# Access Compliance Report

## Public Rights-of-Way

Intersection ID: 12293	Main Street: EASTWAY_DR	Cross Street: KILBORNE_DR	Location: S
ADA ID: A98D5456B9F1	Ramp Type: PerpDiag	Initial Pass/Fail: Fail	Overall Compliance: No
			Severity Score: 13.75

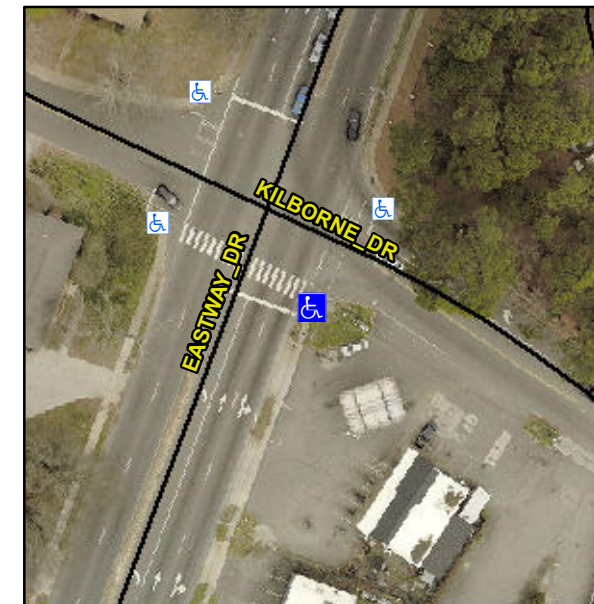
**Not Found, R304.2.2**

Compliance	Description	Data	Compliance	Description	Data
N/A	Ramp Length (in)	60.0	No	Ramp Slope (%)	10.9
Yes	Ramp Width (in)	50.0	Yes	Ramp XSlope (%)	3.5
N/A	Flare Type LT	N/A	N/A	Flare Type RT	N/A
N/A	Flare Slope LT (%)	N/A	N/A	Flare Slope RT (%)	N/A
N/A	Flare Traversable LT?	N/A	N/A	Flare Traversable RT?	N/A
N/A	Landing Length (in)	N/A	N/A	DWS Provided?	N/A
N/A	Landing Width (in)	N/A	N/A	DWS Contrast?	N/A
N/A	Landing Slope (%)	N/A	N/A	DWS Length (in)	N/A
N/A	Landing X Slope (%)	N/A	N/A	DWS Full Width?	N/A
N/A	Landing Curb? (Y/N)	N/A	N/A	DWS Offset (in)	N/A
N/A	Shared Landing?	N/A			
N/A	Gutter Ponding?	N/A	N/A	Gutter Slope (%)	N/A
N/A	Gutter Lip Ht (in)	N/A	N/A	Gutter X Slope (%)	N/A
N/A	Painted X Walk1?	Yes	N/A	Painted X Walk2?	Yes
	X Walk 1 Direction	To NE		X Walk 2 Direction	To NW
N/A	X Walk 1 Width (in)	110.0	N/A	X Walk 2 Width (in)	131.5
	X Walk 1 Slope (%)	2.8		X Walk 2 Slope (%)	2.2
	X Walk 1 X Slope (%)	2.4		X Walk 2 X Slope (%)	2.9

**Remove & Replace Curb Ramp With Two New Directional Ramps or Equivalent.**
